United States Patent and Trademark Office

Office Action Summary

10/619,295

DETAILED ACTION

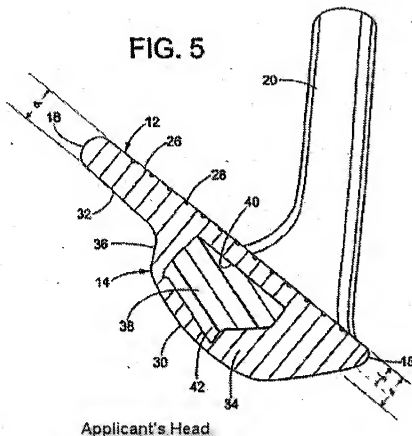
Elkins (4,128,242) discloses a head having a blade surface and a muscle back surface (Fig. 7), a blade surface being near a top edge and substantially parallel to the front face (Fig. 7), a muscle back portion covering at least half of the height of the rear surface as viewed from the toe end (Fig. 7), a cavity (53) disposed in a muscle back portion with a cavity (Figs. 7-8), a cavity vertically spaced from a sole (Fig. 7) and the cavity not visible from the exterior of a club in the form of being able to pour a filler into the cavity (53) and then placing a plug (55) over the cavity (Col. 12, Lns. 30-45) in order to have the moment of inertia about the center of gravity maximized by positioning weight at the heel and toe and in order to add effective loft to a head by having a center of gravity low (Col. 12, Lns. 19-67). Elkins (4,128,242) does not

disclose the back view of the head but does show the outline of the cavity inside the head (Fig. 8). Clearly one skilled in the art in designing the back would have selected a suitable design from toe to heel to support the outline cavity shown in figure 8 in which having a muscle back surface having an upper ledge that generally follows the contour of the top edge and a muscle back portion covering at least half of the surface area of the rear surface are included.

Elkins (4,128,242) lacks a muscle back surface having an upper ledge that generally follows the contour of the top edge, a muscle back portion covering at least half of the surface area of the rear surface, a thin sole and the distance between the front surface and the rear surface adjacent the sole is less than the distance between the front surface adjacent the top edge, a cavity disposed in a muscle back portion with the cavity not visible from the exterior of a club and having no visible cavity thereon, a substantial portion of the extra mass portion being positioned below the cavity, an elastomer at least substantially filling a cavity and an elastomer being a polyurethane.

Behrendt discloses an iron with a blade surface and a muscle back surface having a thin sole and the distance between the front surface and the rear surface adjacent the sole is less than the distance between the front surface adjacent the top edge as measured by the Applicant which is approximately perpendicular from the striking face surface (Fig. 2). See drawings in next sheets comparing the Applicant's measurements on the Applicant's inventive head (Page 6 of the Brief dated 20 February 2007) and the Examiner measuring the same way on the head of Behrendt.

In view of Behrendt it would have been obvious to modify the head of Elkins (4,128,242) to have a thin sole and the distance between the front surface and the rear surface adjacent the sole being less than the distance between the front surface adjacent the top edge in order to have a sharp leading edge of an iron which easily cuts through the ground when the swing requires a divot to be produced so the golfer feels less obstruction from the ground when producing a divot.

Elkins (4,128,242) has a lip at the back sole which one skilled in the art may define as forming a cavity on the back of the muscle back portion. Viollaz discloses a

cavity not visible from an exterior of a club, a cavity vertically spaced from the sole (Figs. 4-5), a thin sole (Fig. 4), a muscle back surface being rounded and having no visible cavity thereon (Figs. 2-3), a substantial portion of the extra mass portion being positioned below the cavity in the form of the bottom cavity wall being a substantial greater thickness than the top cavity wall (Fig. 4) and a cavity substantially filled with a foamed urethane in the form of polyurethane (Col. 2, Lns. 46-50). In view of the patent of Viollaz it would have been obvious to modify the head of Elkins (4,128,242) to have no lip where the muscle back surface intersection with the sole surface, and a substantial portion of the extra mass portion being positioned below the cavity in order to have a more rounded intersection where the rear surface and the sole surface intersect and as such have a head with less interaction with the ground when impacting the back of the sole with the ground when impacting a ball on the ground and still have a weighted sole section. As such there would be a muscle back portion having no visible cavity thereon. In view of the patent of Viollaz it would have been obvious to modify the head of Elkins (4,128,242) to have the cavity substantially filled with foamed polyurethane in order to provide vibration dampening to a head at impact and in order to utilize a shock absorption material placed inside heads used in the market place.

It would have been obvious to modify the head of Elkins (4,128,242) to have a muscle back surface having an upper ledge that generally follows the contour of the top edge and a muscle back portion covering at least half of the surface area of the rear surface in order to maximize lowering the center of gravity of the head and in order to have the generally same cross section of the head from face to back as shown from the toe view in figure 7 all the way to the heel to make the head generally symmetric so ball hits on the toe or heel side of the face have the same performance.

3. The argument that Behrendt is improper due to having a wide sole is disagreed with. If the sole of Behrendt is measured the same way as the Applicant measures the sole Behrendt is able to have a distance which is less at the sole than at the top edge. The argument that the Examiner agrees based on a figure 6 on page 6 of the response that Elkins does not have the claimed feature is disagreed with. This figure 6 is not any of the prior art used to reject the claim in the Office Action dated 2 April 2009. Actually it was the Elkins (D244,558) reference originally used to reject the claimed feature. In fact the Examiner still stands by that this figure 6 of Elkins (D244,558) does read on the feature being discussed. This was pointed out on page 14 of the Office Action dated 2 April 2009.
